Amphenol Taiwan Corporation Product Change Notification

Product Change Notice

Changed 60pos. H11.7mm reel width from 56mm to be 44mm

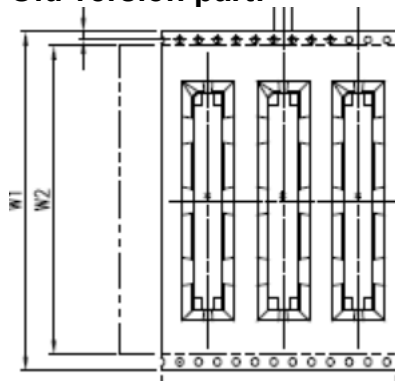
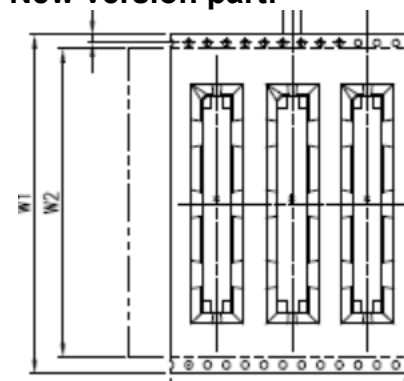
Customer's requirement: Reel width need be same with the first source;
Changed 60pos. H11.7mm reel width from 56mm to be 44mm

G832MX0X0606X22HR	11.70	60	56.0	49.5	250	1250
PART NUMBER	HEIGHT	POS.	DIM. W1	DIM. W2	PCS/REEL	PCS/CARTON

G832MB0X0606X22HR	11.70	60	44.0	37.5	250	1250
PART NUMBER	HEIGHT	POS.	DIM. W1	DIM. W2	PCS/REEL	PCS/CARTON
